Intel® Desktop Board D875PBZ Specification Update

Release Date: August 2004

Order Number: C40099-010

4. *Change to Thermal Considerations, Section 2.12*

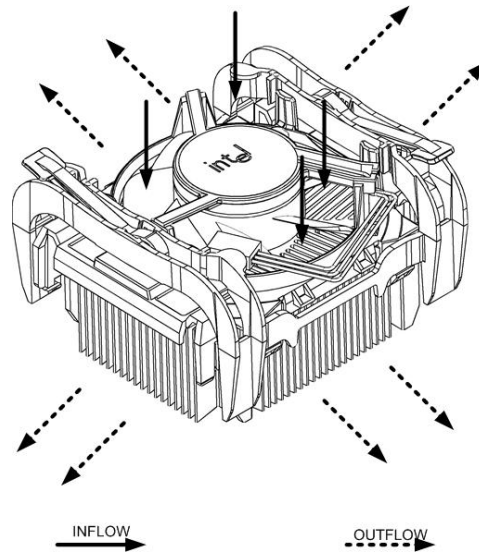
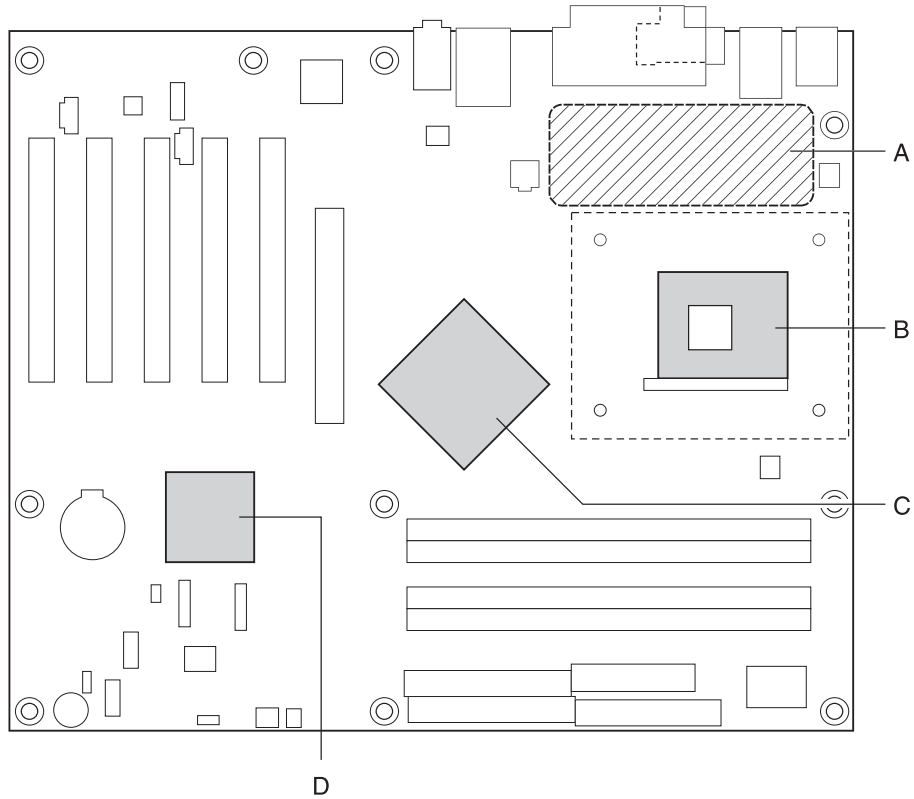
Section 2.12, Thermal Considerations will change in its entirety as follows:

The use of an Intel® Pentium® 4 processor operating above 2.80 GHz with this Intel® desktop board requires the following:

- *A chassis with appropriate airflow to ensure proper cooling of the components on the board*
- *A processor fan heatsink that meets the thermal performance targets for Pentium 4 processors operating above 2.80 GHz*

The use of an Intel Pentium 4 processor with 1 MB of L2 cache on this Intel desktop board requires the following:

- *A chassis with a maximum internal ambient temperature of 38 Degrees Celsius*
- *A processor heatsink that provides omnidirectional airflow so that air is drawn across the processor voltage regulator area (item A in Figure 27). Figure 26a illustrates an omnidirectional airflow heatsink.*

Ensure that proper airflow is maintained in the processor voltage regulator circuit. Failure to do so may result in damage to the voltage regulator circuit. The processor voltage regulator area (item A in Figure 27) can reach a temperature of up to 85 °C in an open chassis.
